# Access Compliance Report

### (Curb Ramps)

Intersection ID: 4687	Main Street: EVANSHIRE_DR	Cross Street: FELDBANK_DR	Location: SW
ADA ID: 79BA53EA88B4	Ramp Type: BlendTrans2	Initial Pass/Fail: Fail	Overall Compliance: No
Severity Score: 8.75			
Codes/Mitigation Info/Possible Solution		Field Measurements/Component Compliance

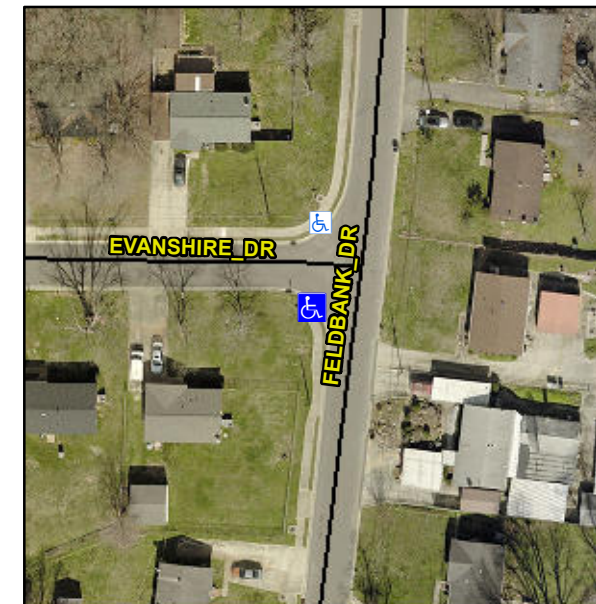
**NO RT SW**

**Not Found, R304.5.1**

Compliance	Description	Data	Compliance	Description	Data
N/A	Ramp Length (in)	83.0	Yes	BlendTrans Slope (%)	4.1
No	Ramp Width (in)	38.0	Yes	BlendTrans XSlope (%)	1.2
N/A	Flare Type LT	N/A	N/A	Flare Type RT	N/A
N/A	Flare Slope LT (%)	N/A	N/A	Flare Slope RT (%)	N/A
N/A	Flare Traversable LT?	N/A	N/A	Flare Traversable RT?	N/A
N/A	Landing Length (in)	N/A	N/A	DWS Provided?	N/A
N/A	Landing Width (in)	N/A	N/A	DWS Contrast?	N/A
N/A	Landing Slope (%)	N/A	N/A	DWS Length (in)	N/A
N/A	Landing X Slope (%)	N/A	N/A	DWS Full Width?	N/A
N/A	Landing Curb? (Y/N)	N/A	N/A	DWS Offset (in)	N/A
N/A	Shared Landing?	N/A			
N/A	Gutter Ponding?	N/A	N/A	Gutter Slope (%)	N/A
N/A	Gutter Lip Ht (in)	N/A	N/A	Gutter X Slope (%)	N/A
N/A	Painted X Walk1?	No	N/A	Painted X Walk2?	N/A
	X Walk 1 Direction	To N		X Walk 2 Direction	N/A
	X Walk 1 Width (in)	N/A		X Walk 2 Width (in)	N/A
	X Walk 1 Slope (%)	3.2		X Walk 2 Slope (%)	N/A
	X Walk 1 X Slope (%)	1.5		X Walk 2 X Slope (%)	N/A

N/A	Ramp inside XWalk1?	N/A	N/A	Ramp inside XWalk2?	N/A
	Road Slope (%)	1.5		Clear Space?	N/A
	Road X Slope (%)	3.2	N/A	Clear Space to XWalk (in)	N/A
N/A	Any Obstructions?	N/A	N/A	Storm Grate/Utility Hazard?	N/A
	Obstruction Type			Storm Grate/Utility Type	
		N/A			N/A
			Yes	Surface Condition? (G/P)	Good
			No	Curb Slope (%)	18.3

**Remove & Replace Curb Ramp With Two New Directional Ramps or Equivalent.**
